1CAN081203

Subject: ANO-1 Cycle 24 COLR, Revision 4
Arkansas Nuclear One - Unit 1
Docket No. 50-313
License No. DPR-51

ANO-1 Cycle 24 Core Operating Limits Report (COLR), Revision 4

Figure 9A**LOCA Linear Heat Rate Limits for Mark-B-HTP Fuel**

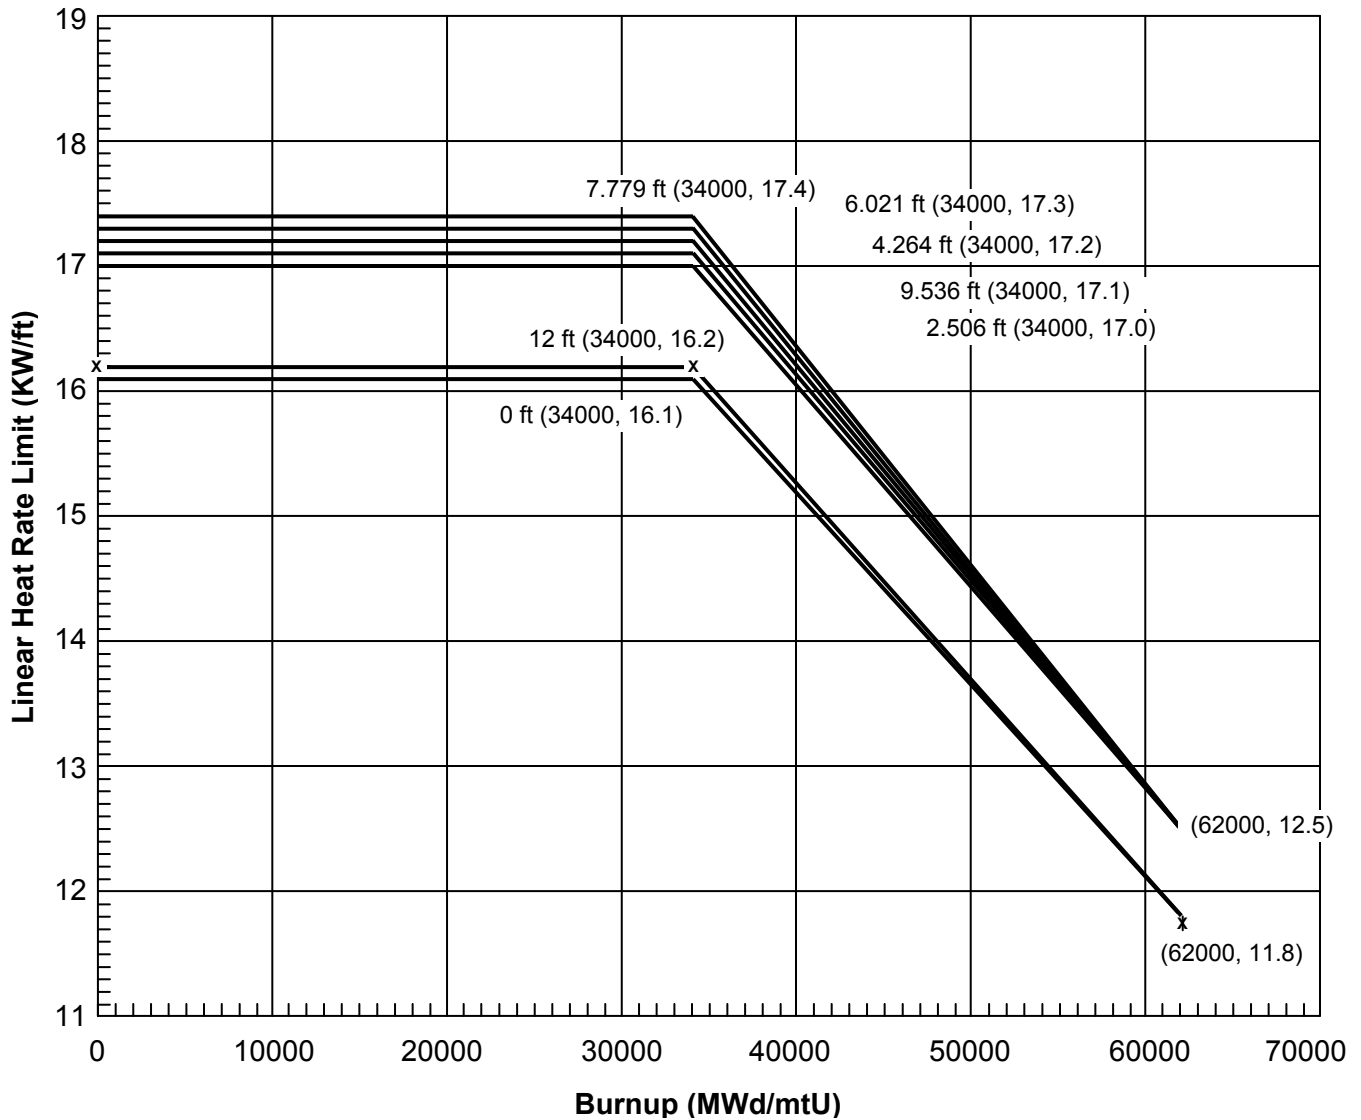
Revision 4 of the COLR corrects editorial errors which occurred during transition of the information in the COLR base calculation (reload report) to development of the COLR itself. Specifically, the zero (0) foot elevation at a core burnup of 34000 MWd/mtU was inadvertently listed as a Linear Heat Rate (LHR) limit of 16.2 KW/ft in Figure 9A versus the 16.1 KW/ft listed in the reload report. This error has no impact on unit operation and at no time has the LHR limit challenged during Cycle 24 operation. This condition is documented in the ANO Corrective Action Program. In addition, the parenthetical underneath the title on COLR Page 14 is revised to state "Limits" instead of "Figure." Finally, the applicable lines illustrated on Figure 9A are adjusted to more accurately reflect the stated endpoint of (62000, 12.5). No other limits or other information contained in the COLR are affected by this change.
